AGENDA PORTLAND PLANNING BOARD MEETING

To: Sean Dundon, Chair and Members of the Portland Planning Board
 From: Andrew Tufts, Planner
 Date: July 19, 2019
 Re: Development & Redevelopment, 66 State Street, DC 66 State LLC
 Project #: PL-000684-2019 CBL: 044 H001001
 Meeting: July 23, 2019

**Subject: 66 State Street Mixed Use
Response to Peer Review Comments**

SHEET TITLE:
EXISTING CONDITIONS & DEMOLITION PLAN

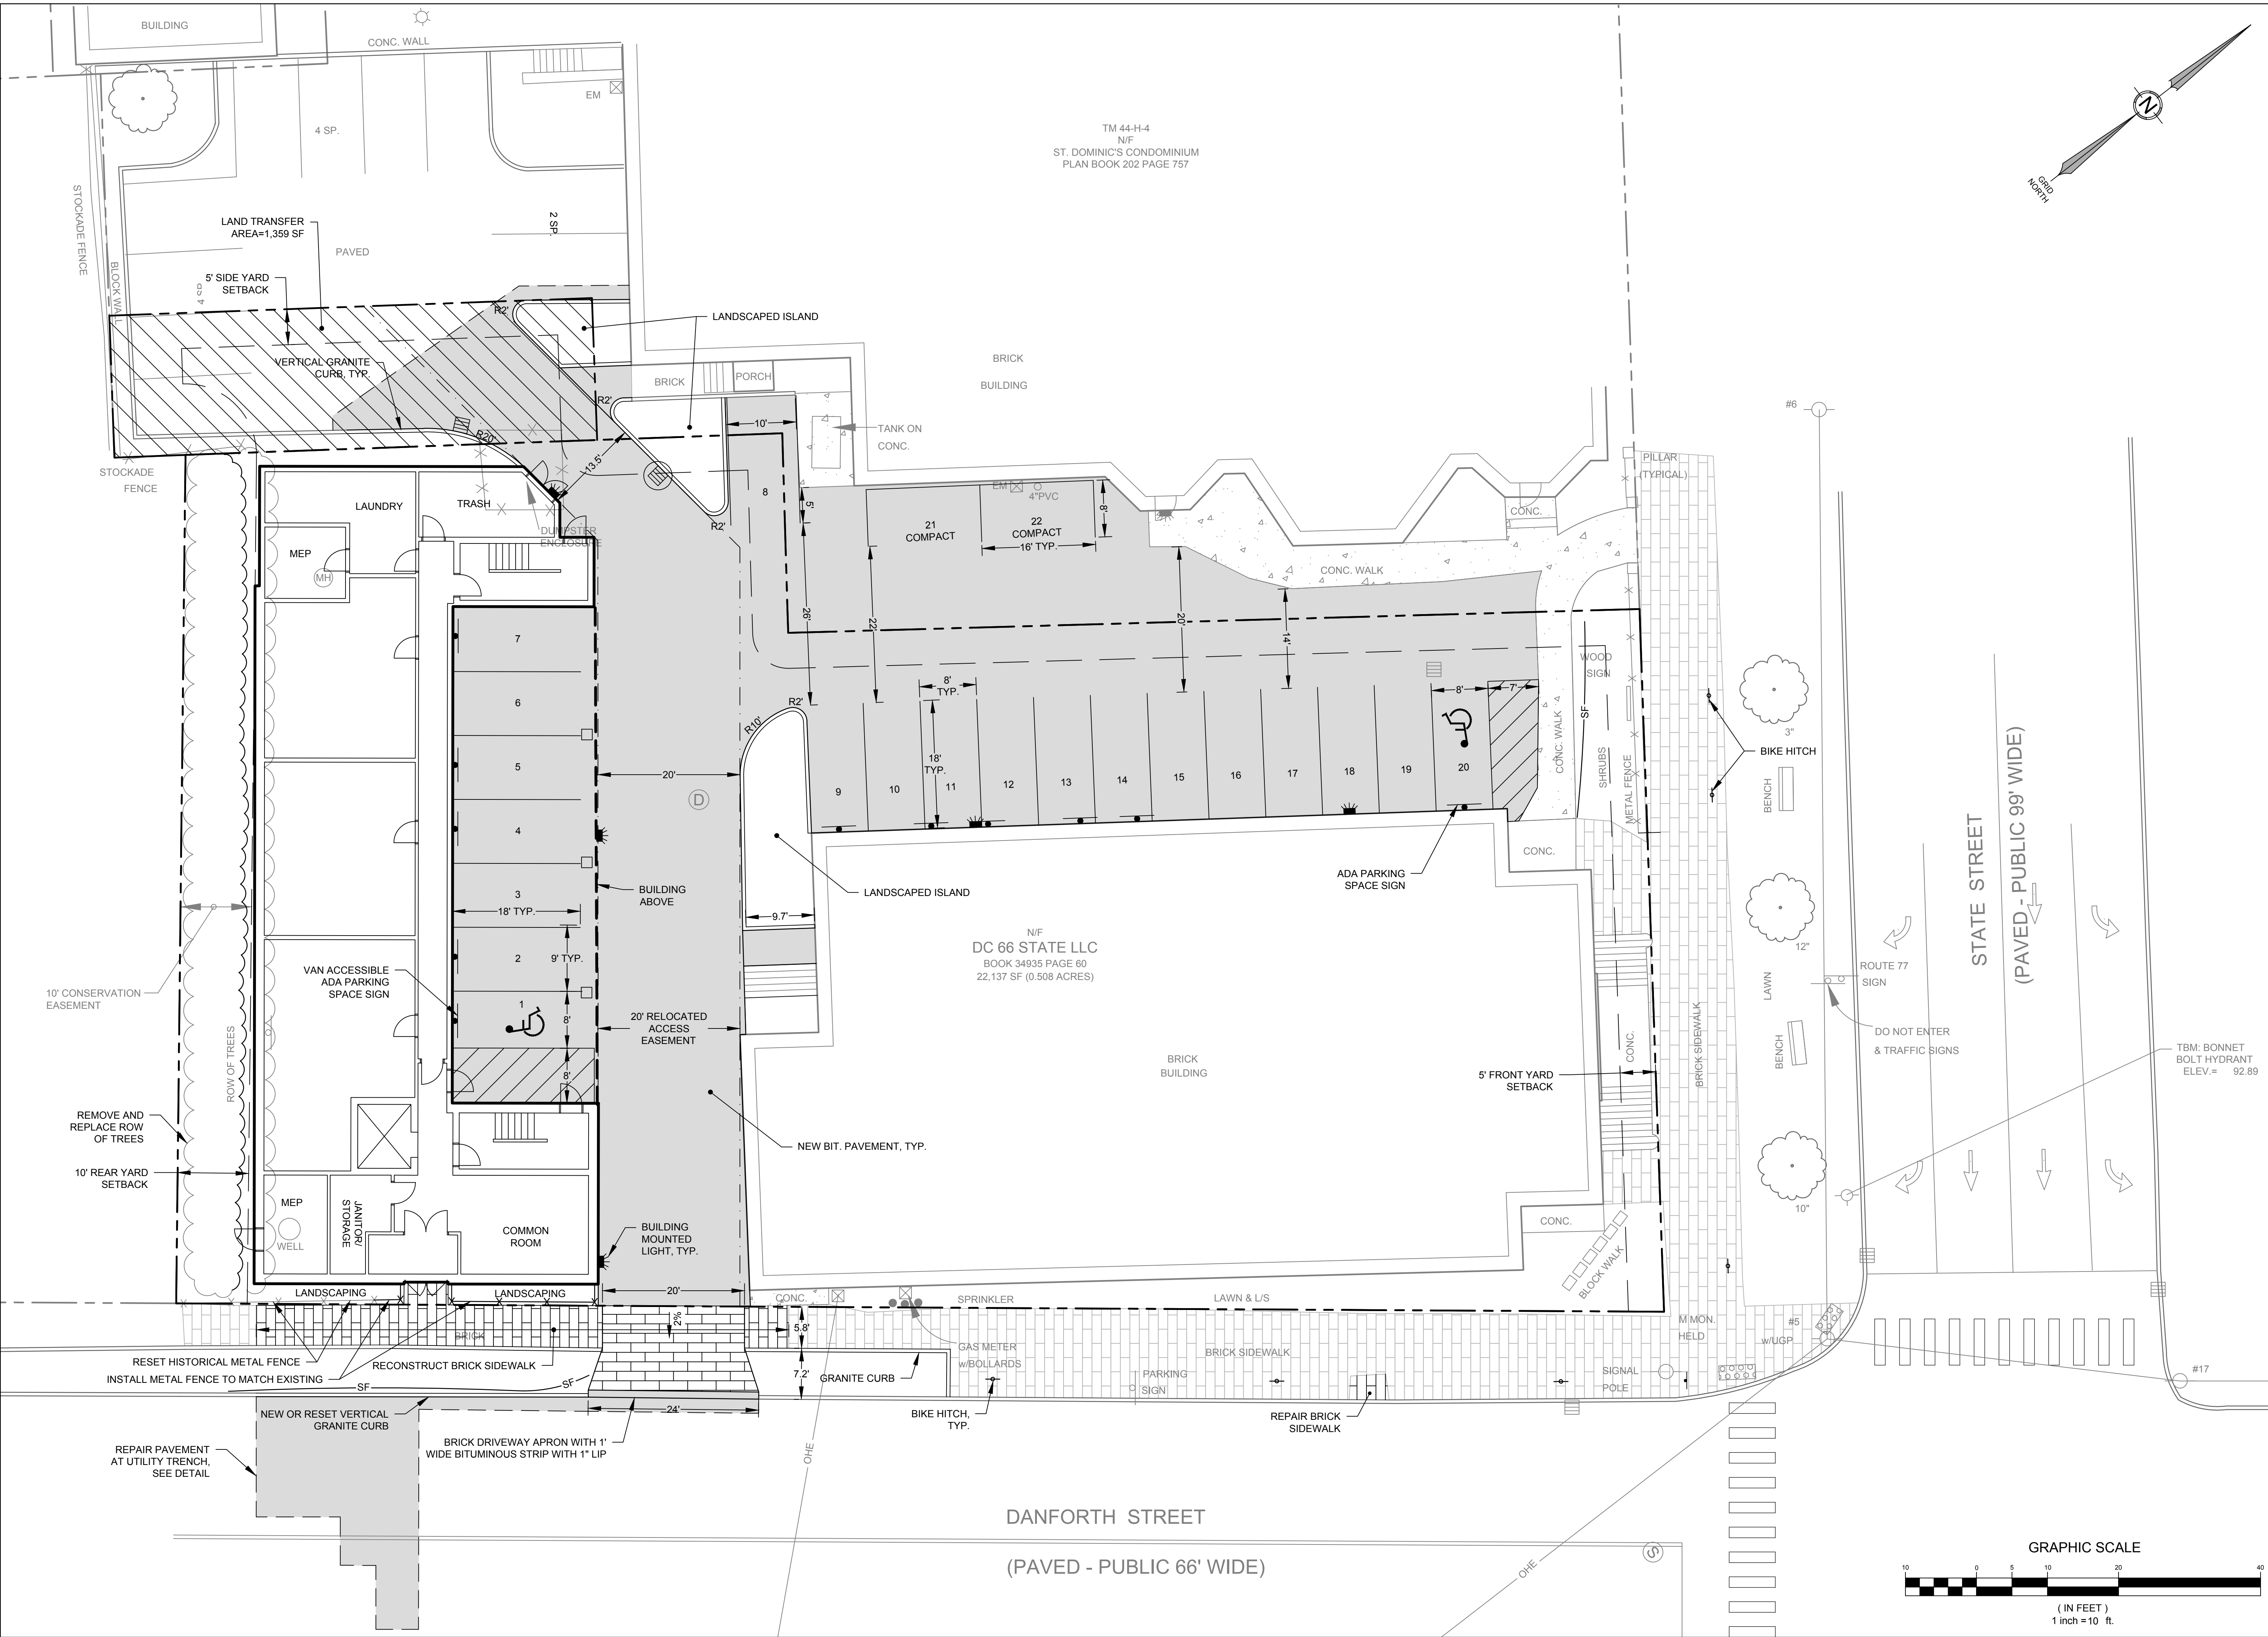
Comment 3: Street Trees, existing and proposed should be shown along Danforth Street.

Response: Existing street trees are shown on sheet C-2.1 Existing Conditions and Demolition Plan. One street tree exists along the Danforth Street frontage directly in front of the proposed building. It must be removed for the construction of the building and installation of underground utilities. Three street trees exist along the site's State Street frontage and will remain.

SHEET C-3.0

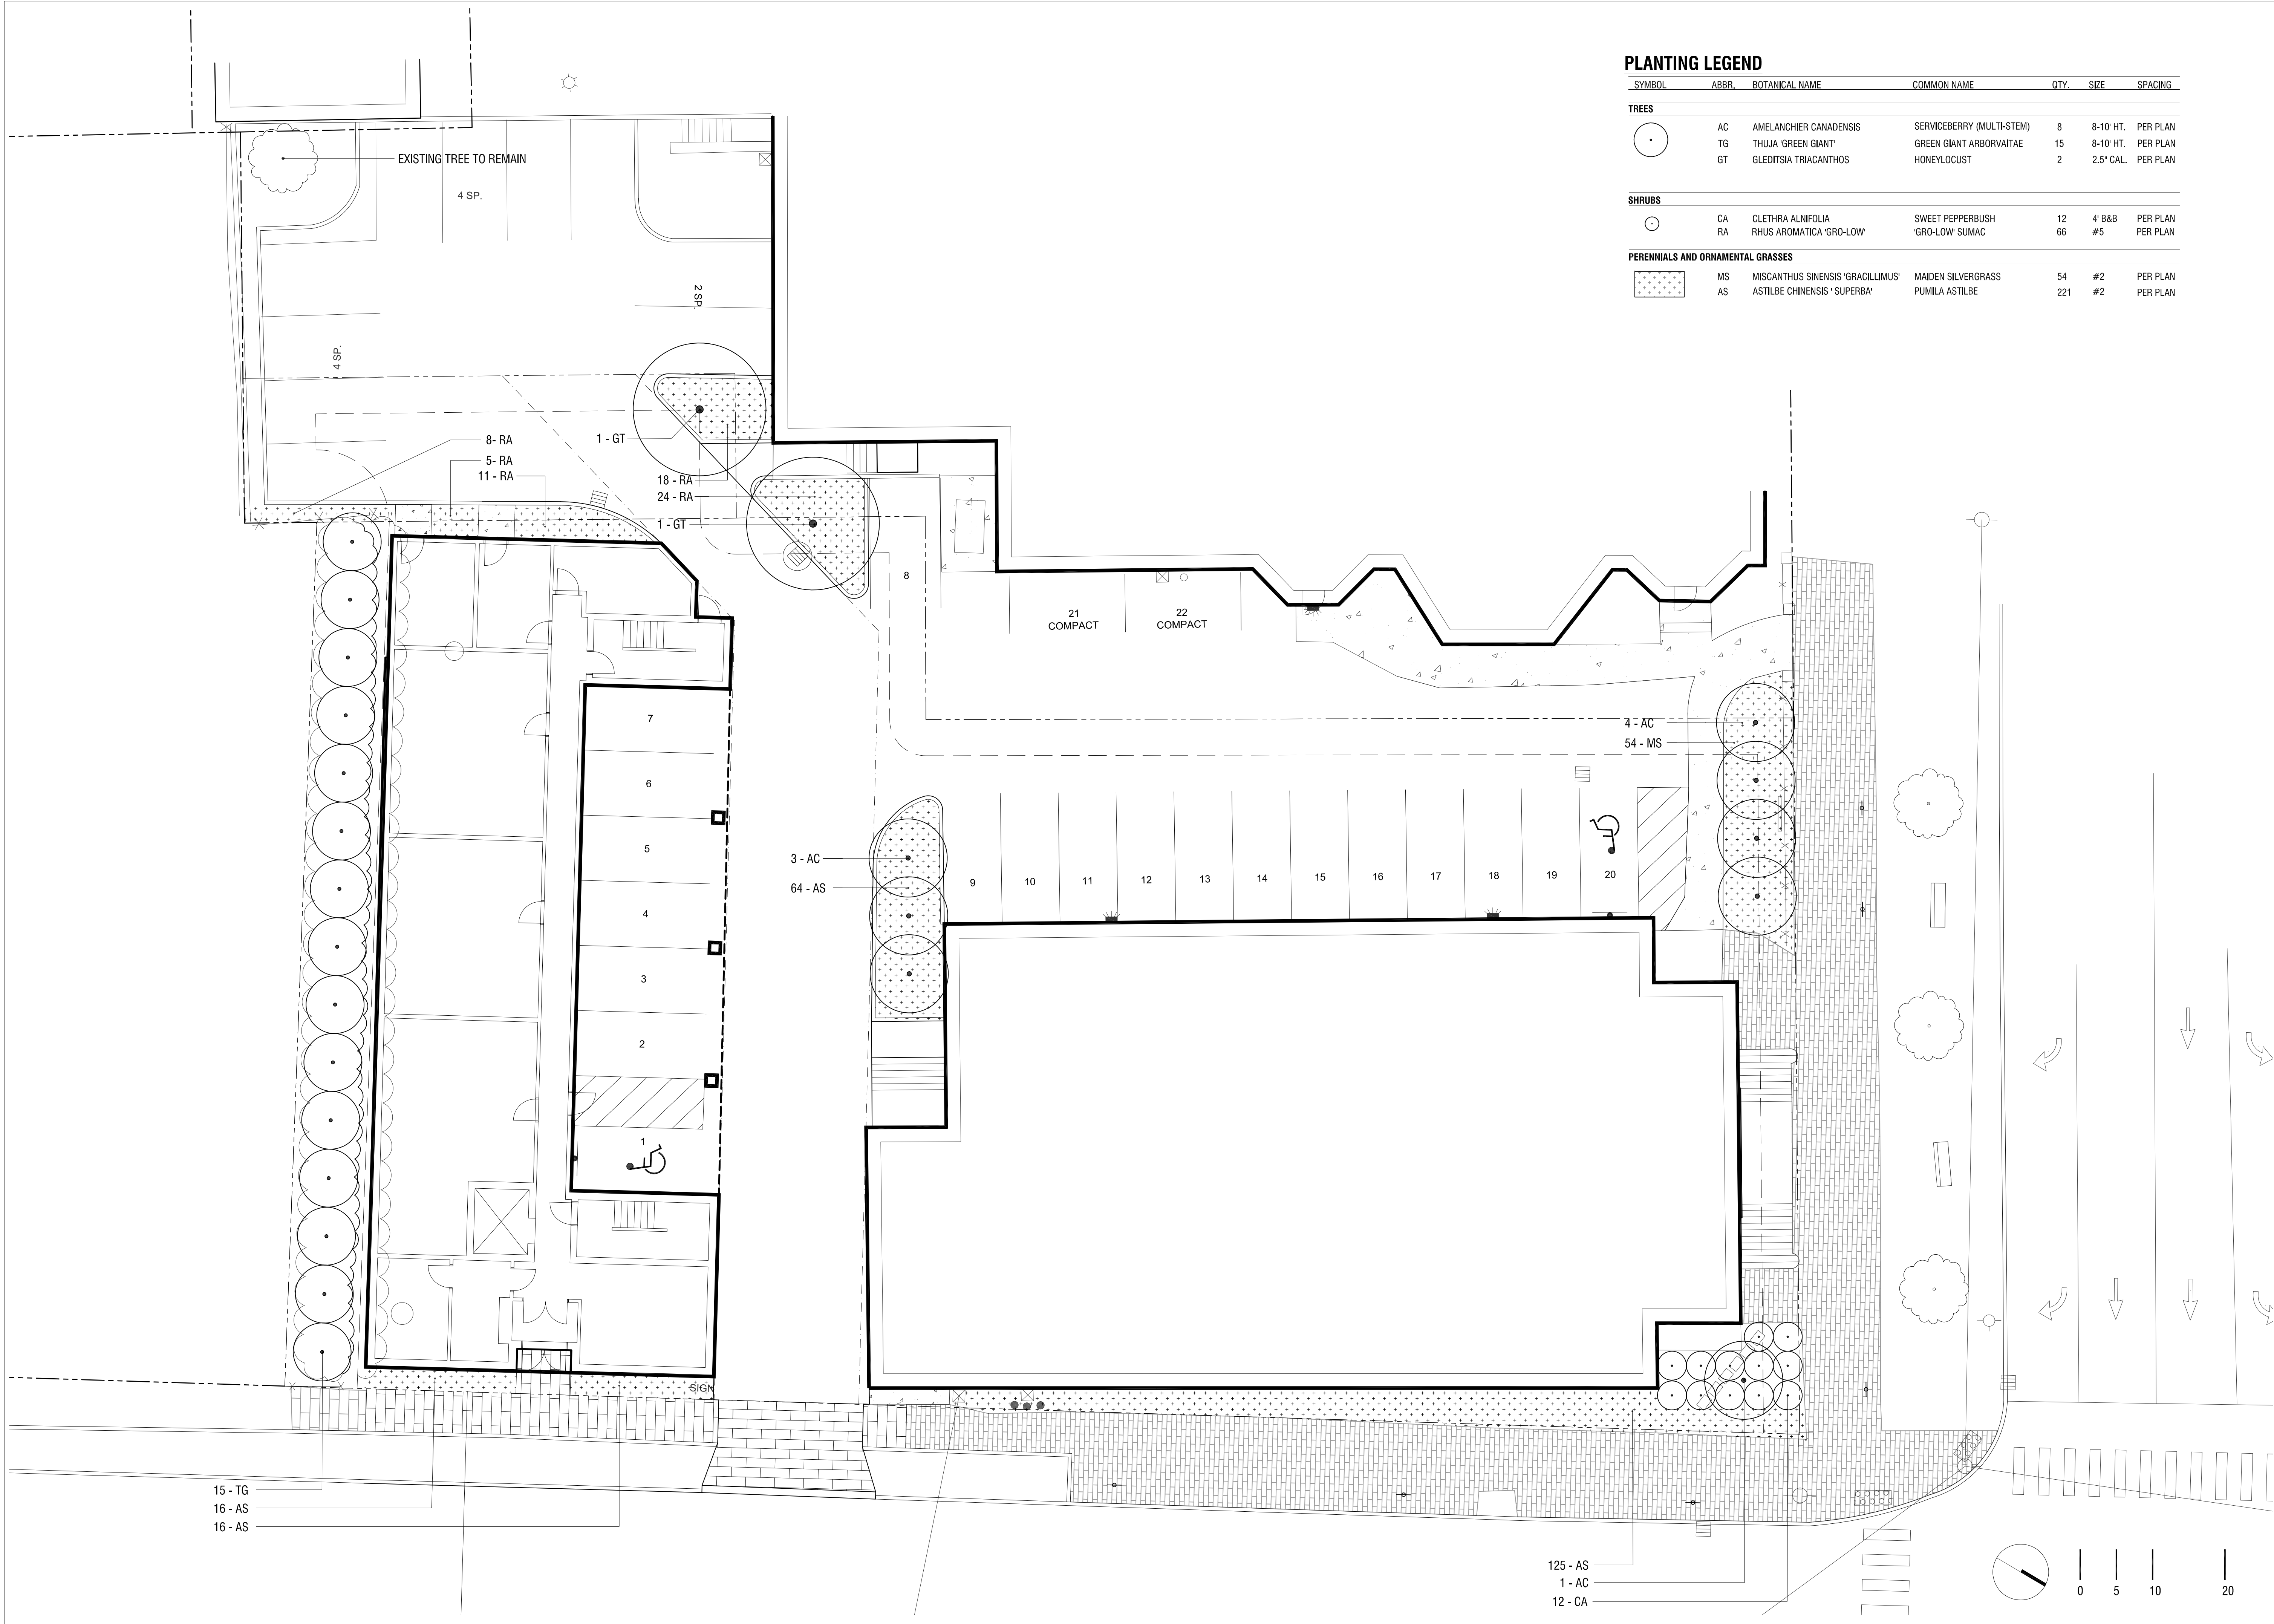
Comment 3: They have two HP spaces. For a 22-space lot, only one is required; however they have two somewhat separate parking areas so providing two is a good idea. However, neither space is technically van-accessible, since for a van space you need an 11-foot wide accessible space with a 5-foot aisle, or an 8-foot space with an 8-foot aisle. Space 1 is a 9-foot space with a 7-foot aisle, so the Applicant should simply restripe that space so it is an 8-foot space next to an 8-foot aisle, and sign that space as a van-accessible space.

Response: Handicap space 1 beneath the proposed building has been re-striped to be 8' wide with an 8' aisle. A label has been added to sheet C-3.0 to specify a van accessible ADA parking space sign. The total width of handicap space 20 is $8' + 7' = 15'$. This is 1' less than a van accessible space but is adjacent to a flush concrete walk so it may be utilized as a van accessible space. A label has been added to sheet C-3.0 to specify an ADA parking space sign.
